Transmission Expansion Advisory Committee DEOK Supplemental Projects

Need Number: DEOK-2025-003

Process Stage: Solutions Meeting 09/08/2026

DEOK Transmission Zone M-3 Process Customer Load Request – **Scope Change #1**

Phase 1 (Temporary Feed, Service up to 300 MW):

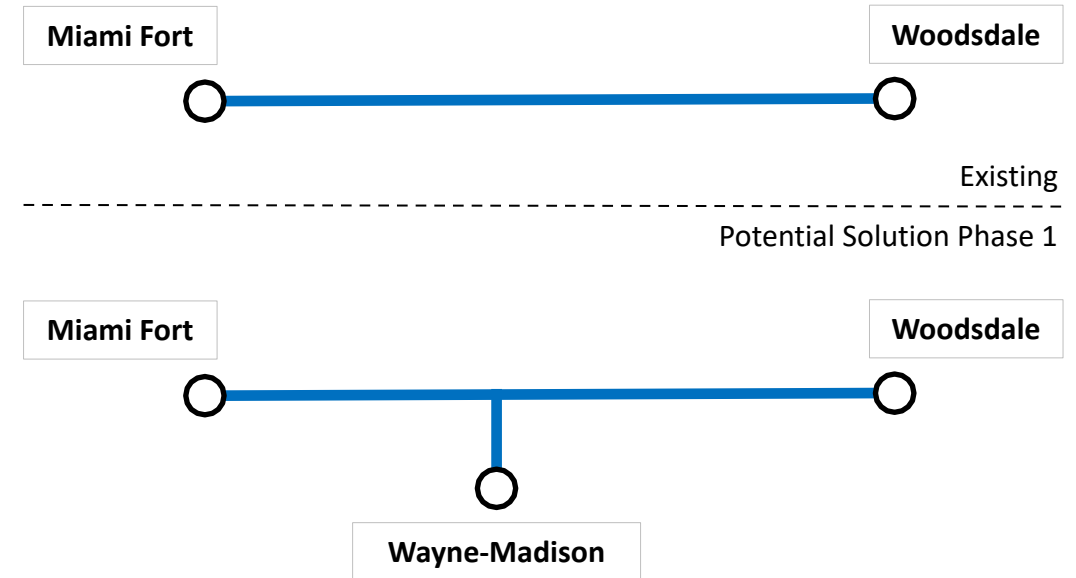
This project is planned to be accomplished in ~~four~~ **three** phases (**numbered 2-3**) coming into service in 2027 and completing by ~~2030~~ **2031**.

Duke Energy will temporarily tap the Miami Fort to Woodsdale 345 kV line for initial service to the customer.

Estimated Transmission Cost: ~~\$0.0M (customer to reimburse costs for temporary service)~~

Proposed In-Service Date: ~~12/31/2027~~

DEOK-2026-004 will render this project phase unnecessary.

Phase 2 (New Wayne-Madison Substation; Service up to 300 MW):

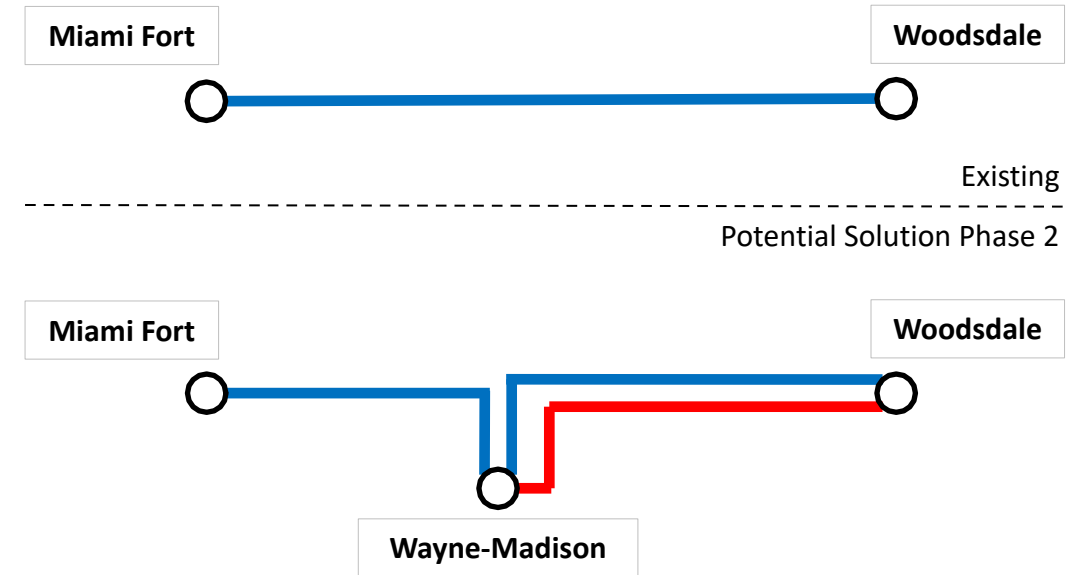
Duke Energy will ~~discontinue the temporary tap feed to customer and~~ construct a new 10-breaker 345 kV breaker-and-a-half switching substation, currently named “Wayne-Madison” at customer location. Wayne-Madison will be looped into existing Woodsdale to Miami Fort 345 kV circuit. ~~Duke will then install two 4000 A, 50 kA, 345 kV circuit breakers in Woodsdale substation for a new circuit, approximately 1.0 mile of bundled 954 ACSR, from Woodsdale to Wayne-Madison.~~ Customer will utilize one or two positions in Wayne-Madison for service.

Estimated Transmission Cost: ~~\$40.0M~~ \$25.9M

Project Status: ~~Scoping~~ Engineering

Model: ~~2024~~ 2025 RTEP

DEOK-2026-004 will render elements of this project phase unnecessary. Project elements now completed by DEOK-2026-004 are shown in the diagram to the right in **RED**.

Phase 3 (New Cotton Run Substation; Service up to 500 MW):

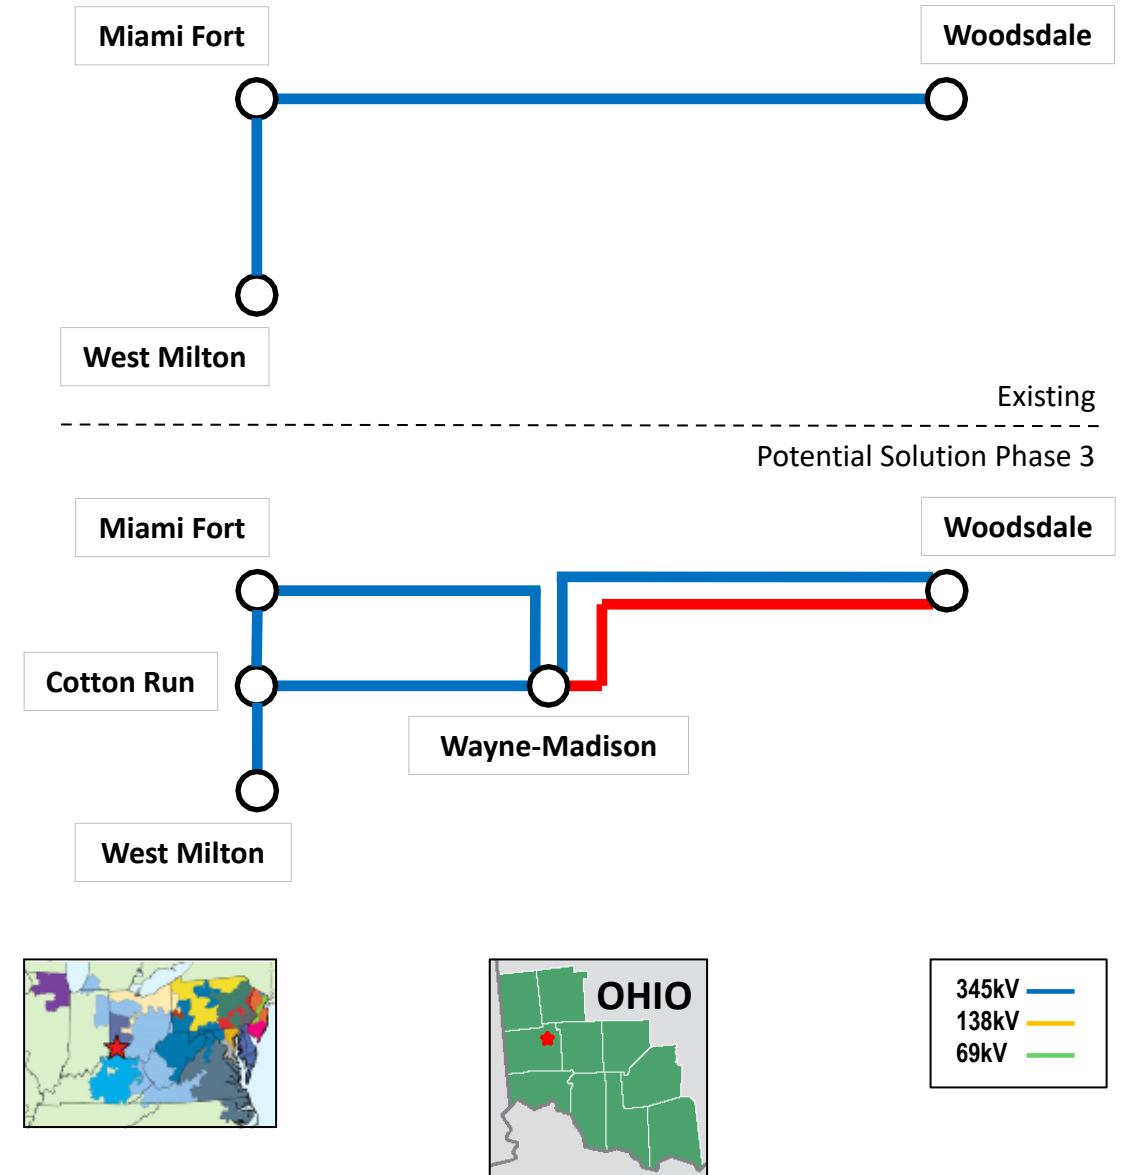
Duke Energy will construct a new switching substation, currently named “Cotton Run”, with a 3-breaker ring bus configuration, utilizing 4000 A, 50 kA, 345 kV circuit breakers, approximately 4.0 miles northwest of Wayne-Madison substation. This substation will be looped through existing Miami Fort to West Milton 345 kV circuit. Approximately 5.5 miles of 954 ACSR, extending from Cotton Run to Wayne-Madison substation.

Project Status: ~~Scoping~~ Engineering

Model: 2024 2025 RTEP

Project elements now completed by DEOK-2026-004 are shown in the diagram to the right in **RED**.

Phase 4.1 (Todhunter to Port Union Rebuild; Service up to 800 MW):

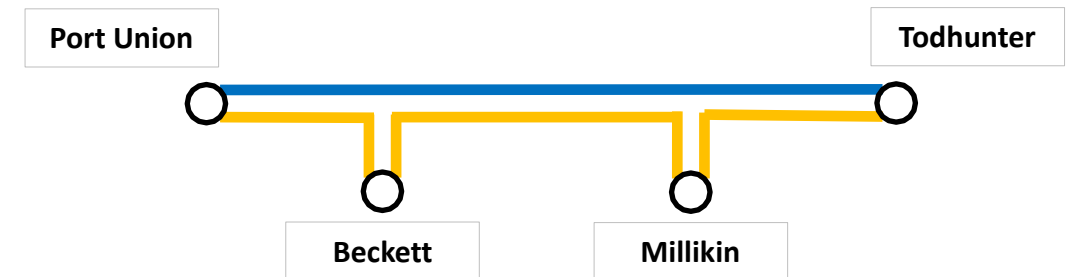
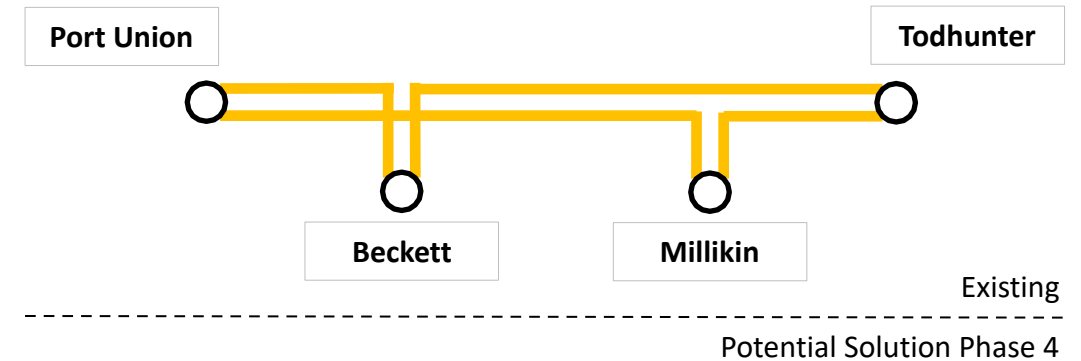
Duke Energy will rebuild two 138 kV circuits 3887 & 3888 connecting Port Union and Todhunter substations, replacing approximately 9.7 miles of each circuit. These circuits are located on both sides of transmission tower infrastructure and will be replaced with bundled 954 kcmil ACSS to allow operation of up to 200 C.

On the eastern side of the shared towers, circuit 3887 will continue to operate at 138 kV. The existing circuit is rated 302/302 MVA summer and 379/379 MVA winter. The updated rating of the circuit will be 480/480 MVA summer and 520/520 MVA winter.

The western side will operate at 345 kV with a rating of 2403/2403 MVA summer and 2604/2604 MVA winter. This circuit will be enabled by the addition of a 345 kV circuit breaker at the Port Union substation and termination in an existing position at Todhunter substation.

Additional Phase 4 project scope was added due to ratings violations identified in the PJM Phase 1 Do-No-Harm analysis.

Phase 4.2 (cont.) (Miami Fort – Willey 138 kV Reconductor; Service up to 800 MW):

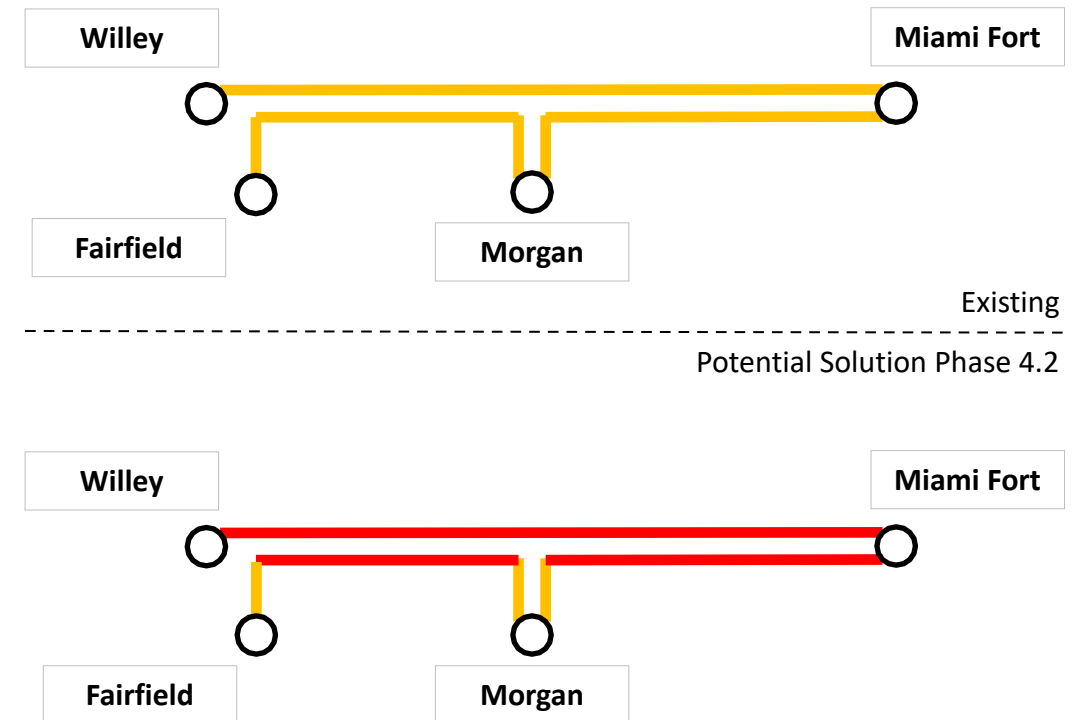
Duke Energy will rebuild 138 kV circuits 9784, 1689 and 5783 from Miami Fort to Willey. Circuit 9784 is approximately 15 miles long, and will be reconducted with 1 Cond/Ph 954 ACSS TW 20X7. This will require the replacement of 78 tower structures with engineered poles as well as replacement of bus conductor at Miami Fort and Willey 138 kV substations. These project elements combined will result in a line ratings increase to 480/480 MVA SUM and 520/520 MVA WIN. These project elements are estimated to cost \$45M.

In anticipation of future load increases and capacity constraints, Duke Energy will reconductor the circuits which share the towers with circuit 9784, to the same 1 Cond/Ph 954 ACSS TW 20X7. This includes approximately 7.4 miles of circuit 1689 from Miami Fort – Morgan substation, as well as approximately 7.2 miles of circuit 5783 from Morgan to the Willey substation area. The ratings on these lines will not change. These project elements are estimated to cost \$20M.

Alternatives Considered: Building an additional 138 kV line from Miami Fort to Willey. This alternative was more costly and limited by available space at both Miami Fort and Willey substations

Additional Phase 4 project scope was added due to ratings violations identified in the PJM Phase 1 Do-No-Harm analysis.

The diagram to the right displays the line to be reconducted in **RED**
